MODIFICATION BULLETIN NO. CRO-001

Model		CSI/CRO USA Version (FAX2500L/3500L)				Date of Modification	
Modified Article		Various				Execution Date	
Reason for Modification		<input checked="" type="checkbox"/> Parts catalog correction <input type="checkbox"/> Vender change <input type="checkbox"/> To meet standards () <input type="checkbox"/> Part standardization <input type="checkbox"/> To facilitate assembly <input type="checkbox"/> To improve reliability <input type="checkbox"/> Other				From the 1st mass production.	
Old Part No.	New Part No.	Description	Q'ty Used Old → New	Interchange- ability	Remarks	Parts Catalog	
						Index No.	Page
AA143287		Stepped Screw - M3	1 → 1		To be used only in CSI	13	1-5
H0812260		Right Ground Plate - Copy Out	1 → 1		To be used in both CSI and CRO	106	1-7
H0813388		Paper Size Detector Pin - Legal - Ricoh	1 → 1		To be used only in CSI	28	1-13
H0813409		Standard Pin	1 → 1		To be used only in CSI	78	1-11

MODIFICATION BULLETIN NO. CRO-005ISSUED ON August 27th, 1993

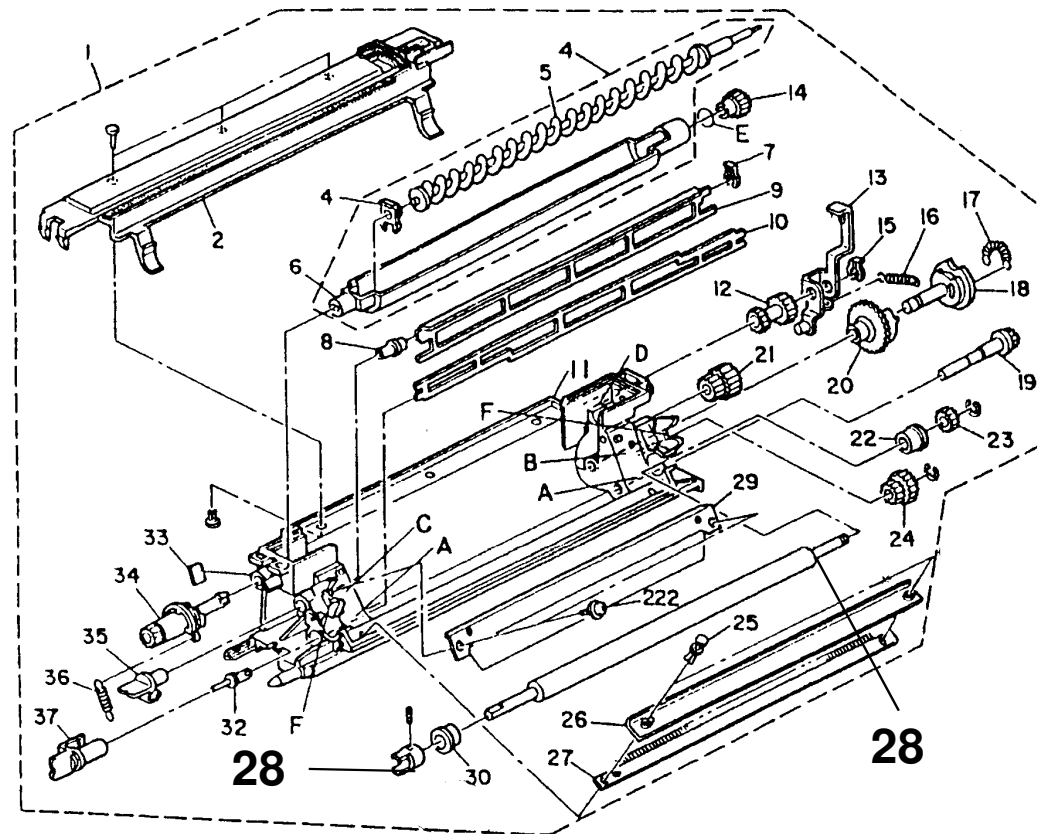
Model	CSI/CRO USA Version (FAX2500L/3500L, NRG9650/9665, OMNIFAX L42/L46, SAVINFAX3630/3670)					Date of Modification	
Modified Article	Development Roller					Execution Date	
Reason for Modification	<div style="display: flex; justify-content: space-between;"> <div> <input checked="" type="checkbox"/> Parts catalog correction <input type="checkbox"/> Vender change </div> <div> <input type="checkbox"/> To meet standards () <input type="checkbox"/> Part standardization </div> <div> <input type="checkbox"/> To facilitate assembly <input type="checkbox"/> To improve reliability <input type="checkbox"/> Other </div> </div> <p>We have cancelled to supply H0812479 itself as a service part. And we have combined it with Developwent Roller (P/No.H0822400, index No.28). See the attached page.</p>					From thes 1st mass production.

Old Part No.	New Part No.	Description	Q'ty Used Old → New	Interchange- ability	Remarks	Parts Catalog	
						Index No.	Page
H0812497		Joint - Development Roller	1 → 0			31	1-7

MODIFICATION BULLETIN NO. CRO-006ISSUED ON August, 27nd, 1993

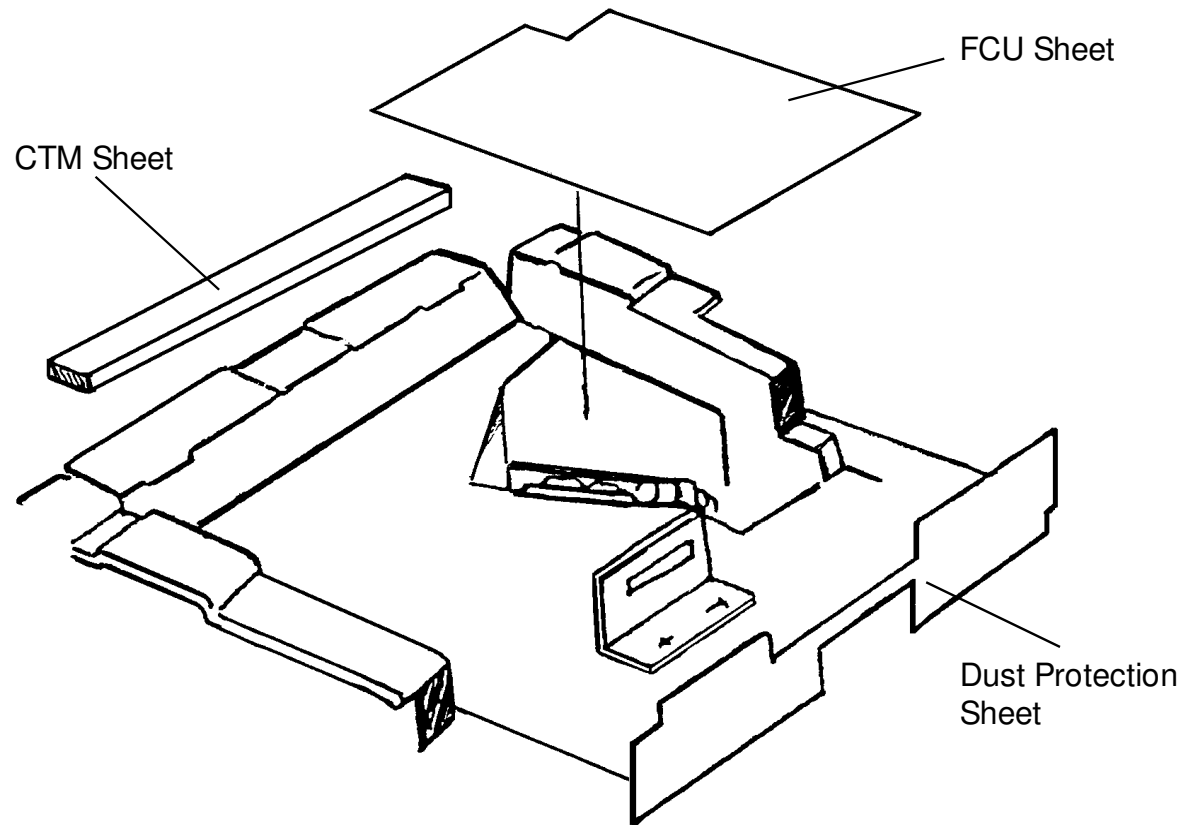
Model		CRO all models				Date of Modification	
Modified Article		Sheet				Execution Date	
Reason for Modification		<input type="checkbox"/> Parts catalog correction <input type="checkbox"/> To meet standards () <input type="checkbox"/> To facilitate assembly <input type="checkbox"/> Vender change <input type="checkbox"/> Part standardization <input checked="" type="checkbox"/> To improve reliability <input type="checkbox"/> Other				From May productions.	
		To protect the mirror from becoming durty.

Old Part No.	New Part No.	Description	Q'ty Used Old → New	Interchange- ability	Remarks	Parts Catalog	
						Index No.	Page
	H081 1236	CTM Sheet	0 - 1			150	5
	H081 1237	FCU Sheet	0 - 1			151	5
	H081 1238	Dust Protection Sheet	0 - 1			152	5
